APPEAL SUMMARY

Status: Decision Rendered - Reconsideration of ID 20302

Appeal ID: 21895	Project Address: 2124 NW Flanders St
Hearing Date: 9/18/19	Appellant Name: Anne Marie Kuban/Brian Emerick
Case No.: B-010	Appellant Phone: (503)235-9400
Appeal Type: Building	Plans Examiner/Inspector: Guy Altman
Project Type: lur	Stories: 4 Occupancy: R-2,S, B Construction Type: V-B
Building/Business Name: 2124 NW Flanders	Fire Sprinklers: Yes - Fully-sprinklered
Appeal Involves: Reconsideration of appeal	LUR or Permit Application No.: 19-207902-EA
Plan Submitted Option: pdf [File 1] [File 2]	Proposed use: Apartments

SECTION THRU EXIT DISCHARGE

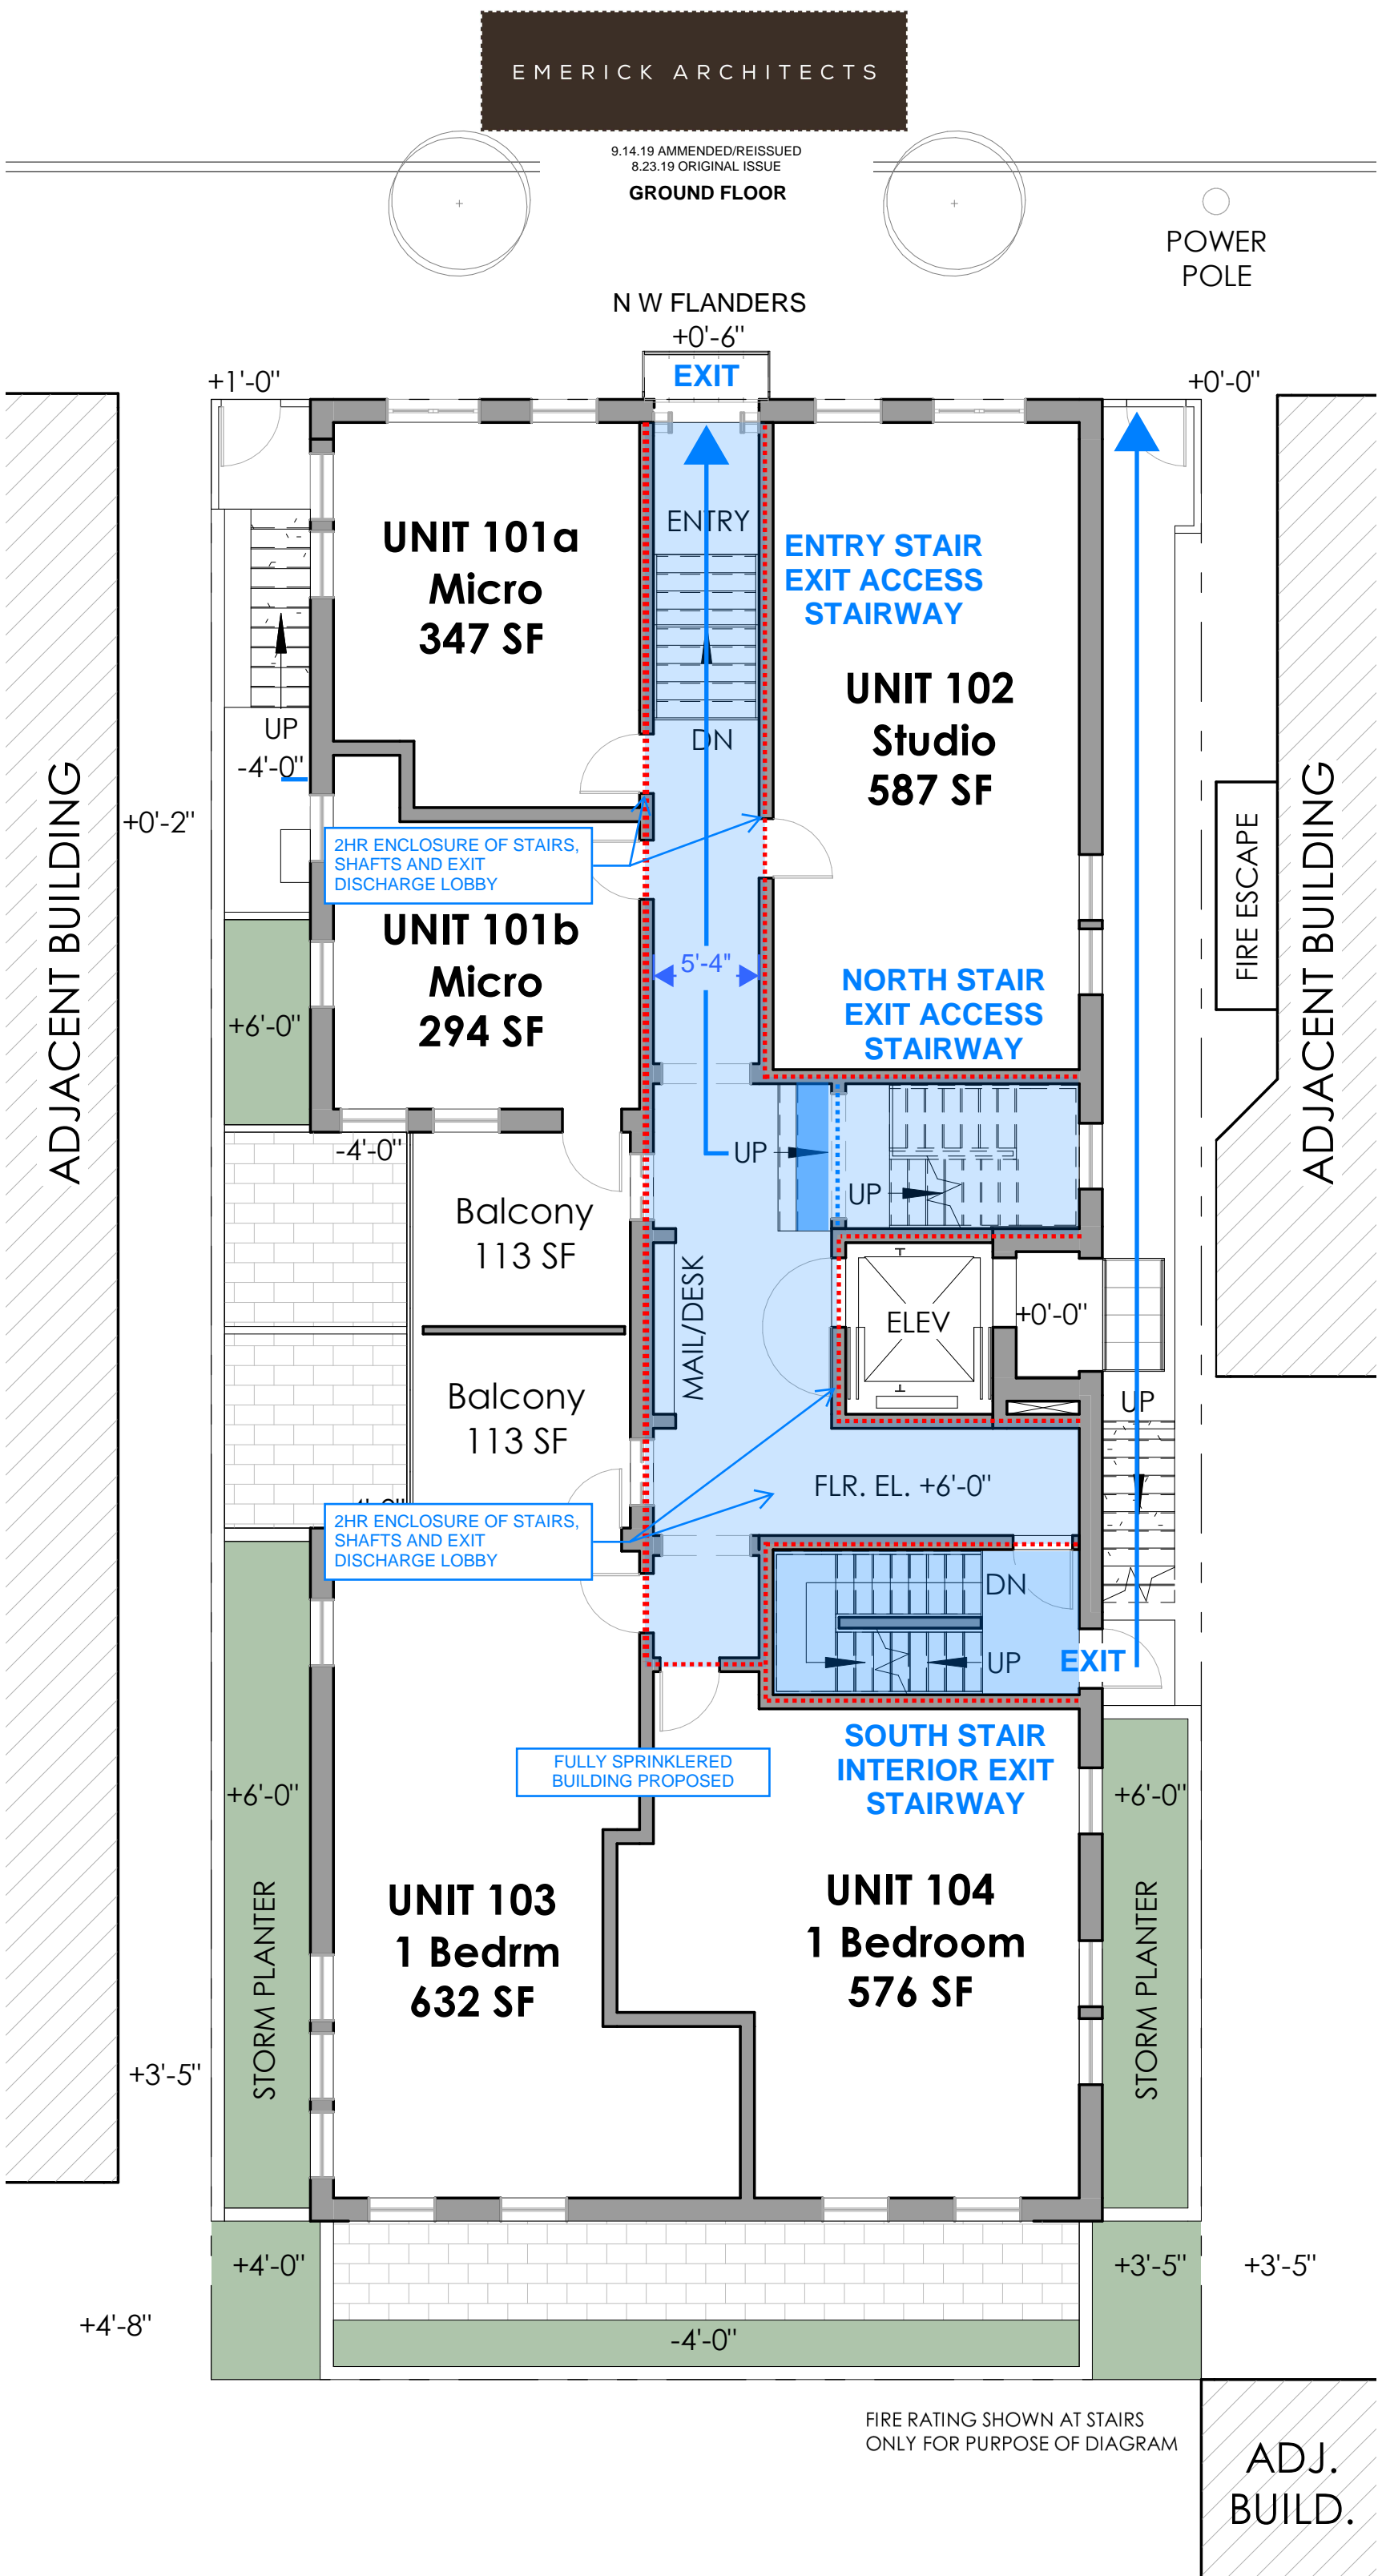
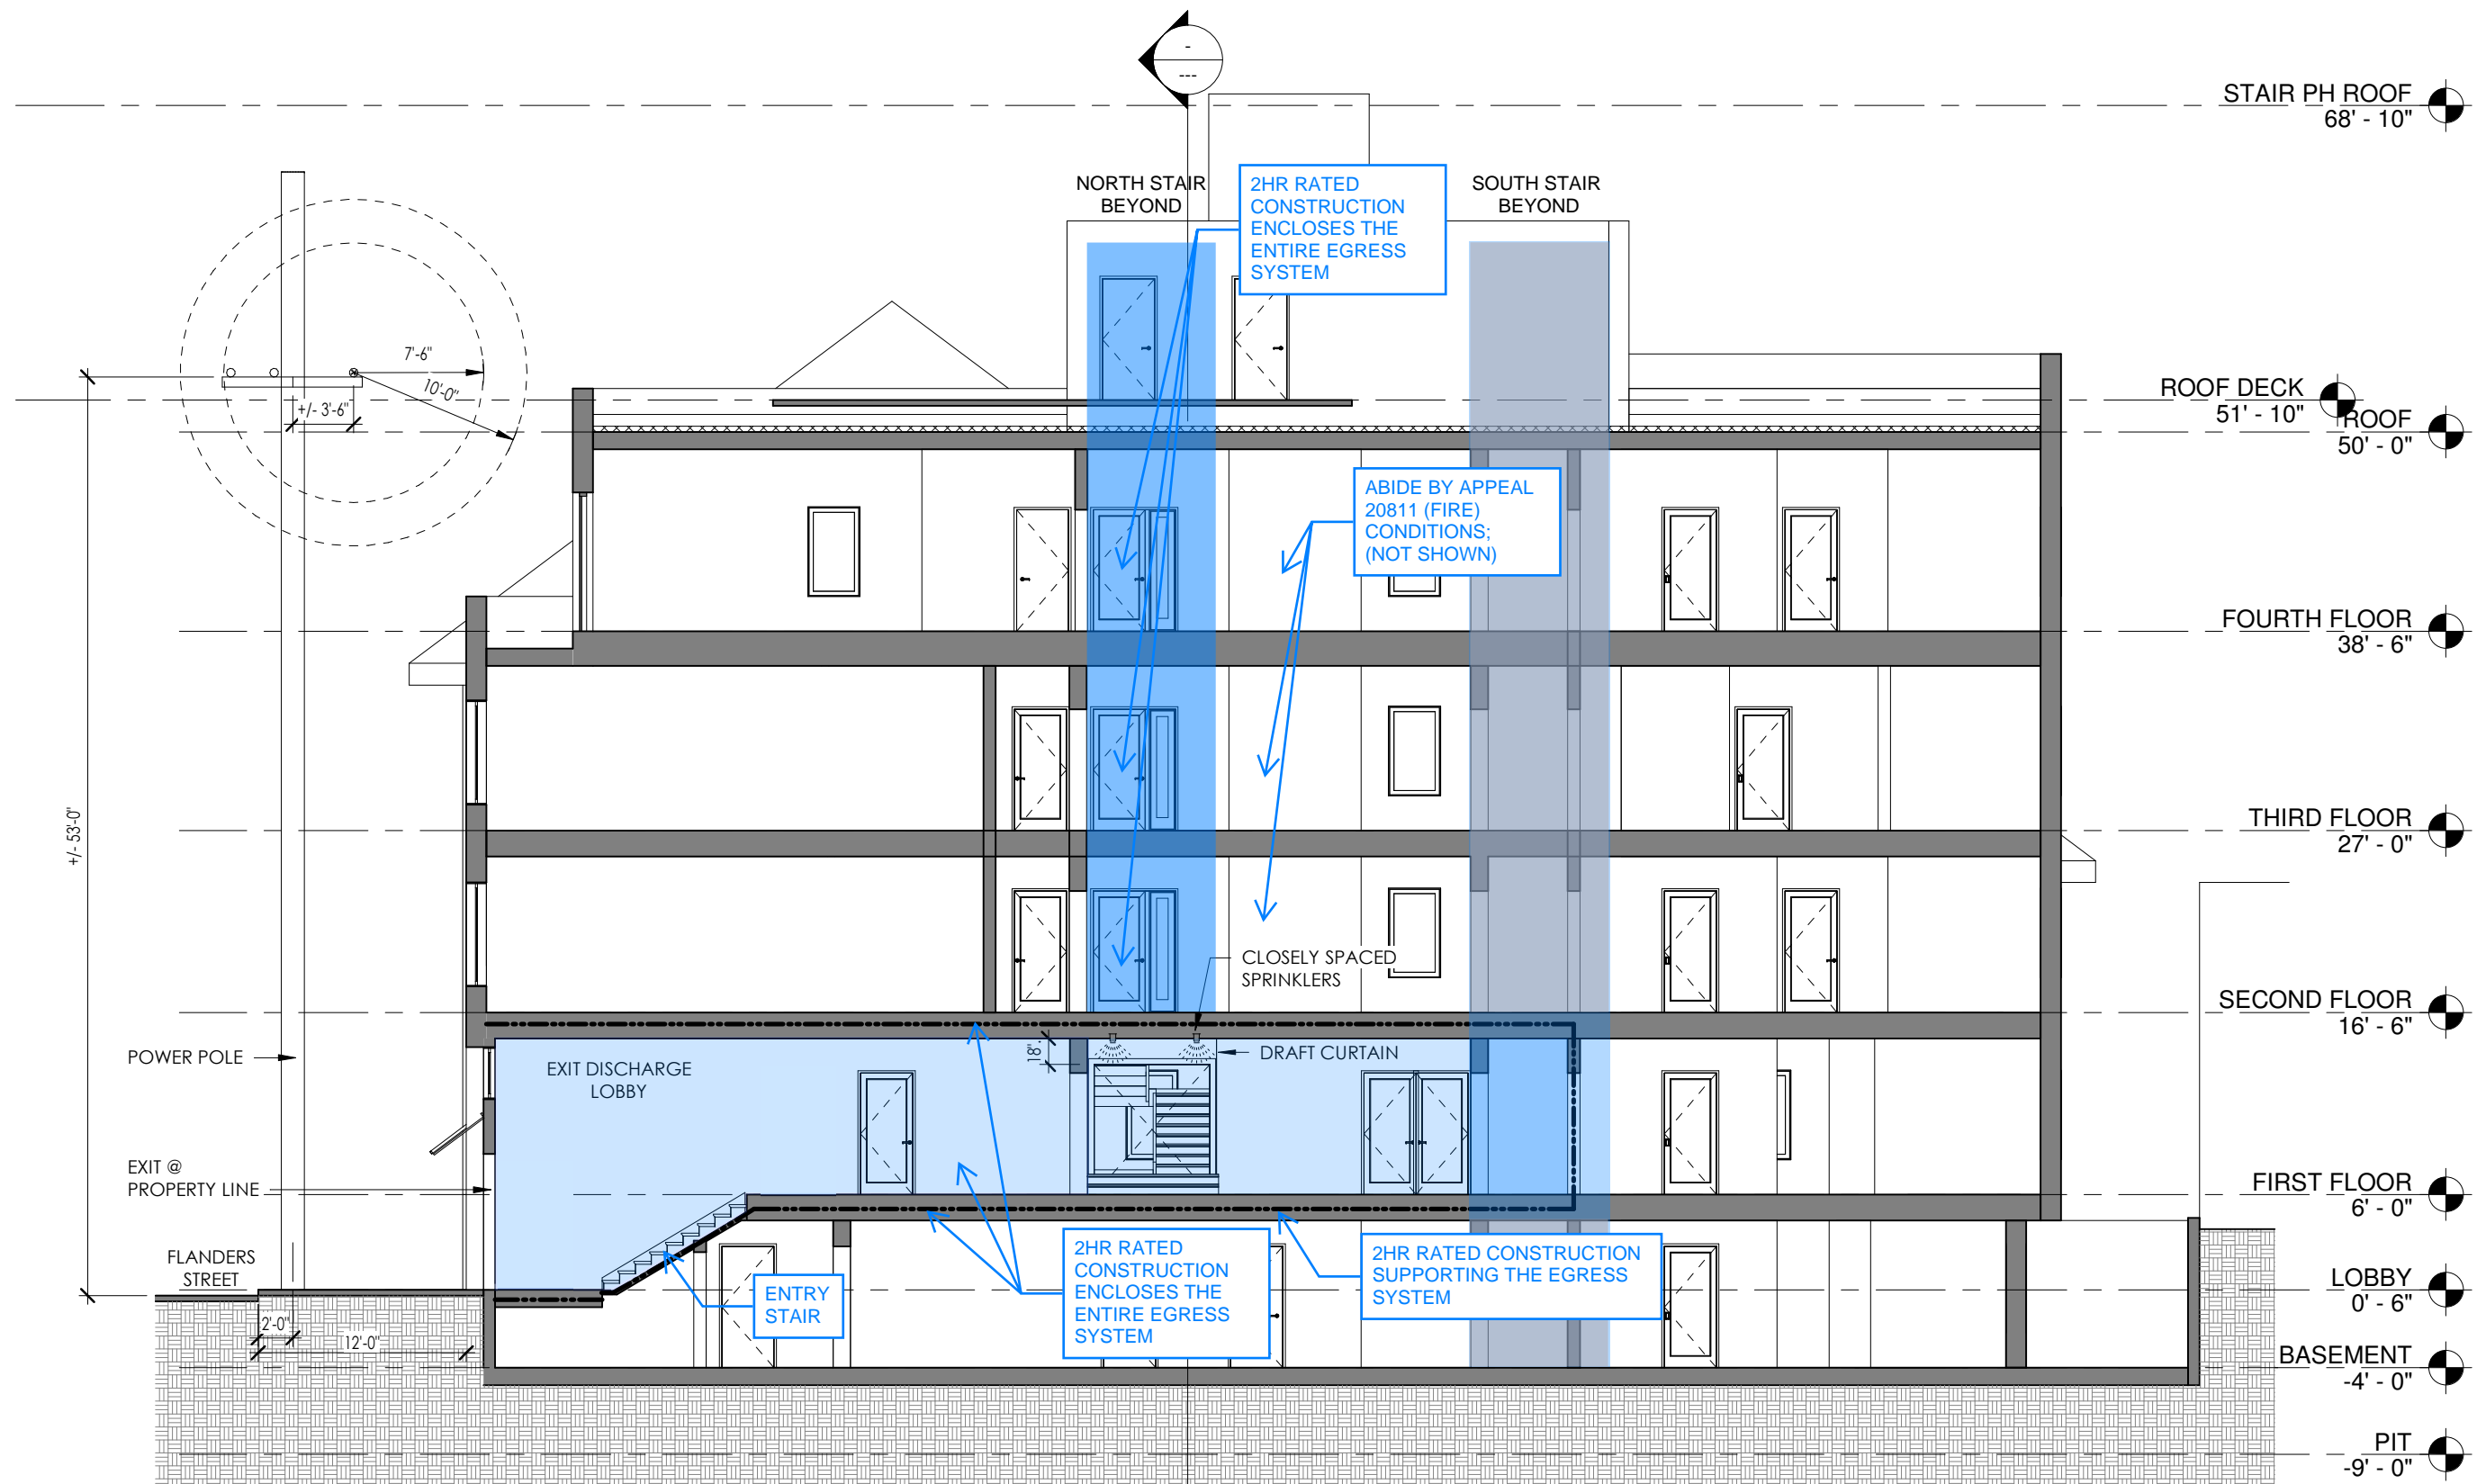
Code Section	OSSC 1007.3
Requires	1007.3 Stairways. "....Exit access stairways that connect levels in the same story are not permitted as part of an accessible means of egress."
Proposed Design	<p>The proposed design includes two egress stairways. Each egress path meets the strict definitions and exceptions allowed by Code.</p> <p>Half of the building's occupant load egresses through the South Stair. It is an enclosed interior exit stairway that extends from the basement level to the roof deck with an exit to the east exterior egress court, leading to the public way. The other half of the building's occupant load egresses through the North Stair and Front Stair (stair in question). The North Stair plus the Entry Stair are both exit access stairways that are enclosed (2HR) at floors 2 through the roof deck. It uses an enclosed exit discharge lobby (2HR) to transfer occupants on the level of exit discharge to the public way. Within the exit discharge lobby there is the Entry Stair which transfers occupants 5'-6" down to the public way.</p> <p>a) OSSC 1007.3 prohibits the use of exit access stairs being used as an accessible means of egress.</p> <p>b) The ICC Code Commentary explains that this prohibition is based upon the understanding that exit access stairs can be found in any location in the building and are not protected. "People with mobility impairments cannot be asked to wait anywhere in the building; they must be able to get to the stairways where the fire department will be coming into the building."</p> <p>c) IBC 2018 Sections repeat the same information; the 2018 Code Commentary also repeats the same discussion.</p> <p>d) Please see attached sheets for Code/Commentary references.</p>

- d) Provides protected (2HR) enclosure for the North Stair and the Entry Stair.
- e) Allows for people with mobility issues to wait in a protected exit access stairway and in a protected exit discharge lobby near the location where fire personnel would be entering the building.
- f) Includes a 5'-4" wide landing at the top of the entry stair, giving wheelchair user space to wait for emergency personnel while allowing egress for able-bodied persons. (No area of refuge is required since the building is fully sprinklered.)

Reason for alternative This Alternate design, the Entry Stairs being both an exit access stairway and an accessible means of egress within a protected enclosure (2HR) is not discussed specifically in the Code. The ICC's own interpretation commentary allows for an exit access stairway being used as an accessible means of egress if it is protected. The proposed design provides a safe egress systems for occupants to the public way in protected construction.

Use of lobby as waiting area for egress assistance: Denied. Proposal does not provide equivalent Life Safety protection.
